Public Input No. 4-NFPA 130-2019 [Global Input]

NFPA[®] 130

Standard for Fixed Guideway Transit and Passenger Rail Systems

Figure A.6.3.2.1 Unobstructed Clear Width for Trainway Walkway.

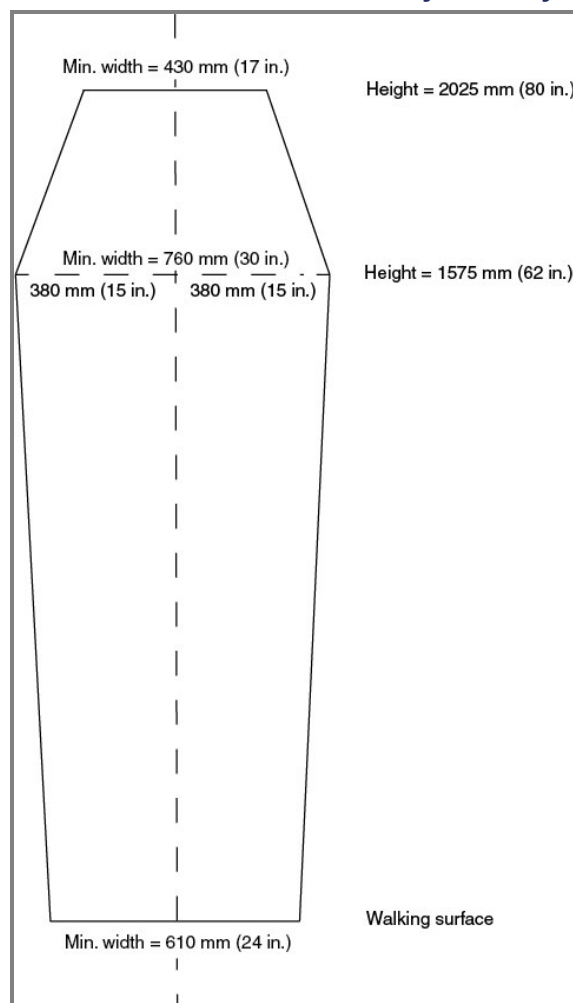
Maintaining a clear space above the walking surface is important to ensure that projections do not encroach into the means of egress. The envelope created by the boundary limits defined by this paragraph is intended to change gradually and symmetrically from point to point. With respect to clearances to the vehicle, the measurements should be to the static vehicle envelope. (See Figure A.6.3.2.1.) *This dimension does not address accessible means of egress within the trainway. Should this be required by the applicable local codes, the width should be increased based upon a hazard analysis.*

Figure C.1.3 Center-Platform Station.

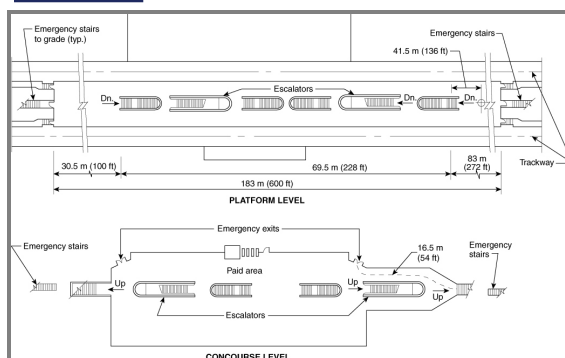
C.2.2.1 _ Center-Platform Station Sample Calculation. Station

The sample center-platform station is an elevated station with the platform above the concourse, which is at grade (see Figure C.1.3). The platform is 183 m (600 ft) long to accommodate the train length. The vertical distance from the platform to the concourse is 9.1 m (30 ft).

Figure C .1.4 Side 2.2.2 Side -Platform Station.

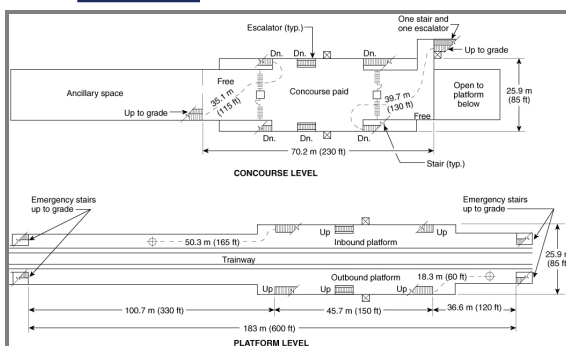
C.12.4.2.2 Side-Platform Station-Sample Calculation. Station

The sample side-platform station is an enclosed station with a concourse above the platform level but below grade. (See Figure C.1.4.) The platform is 183 m (600 ft) long to accommodate the train length. The vertical distance from grade to concourse is 8 m (26 ft). The concourse is 5.5 m (18 ft) above the platform.
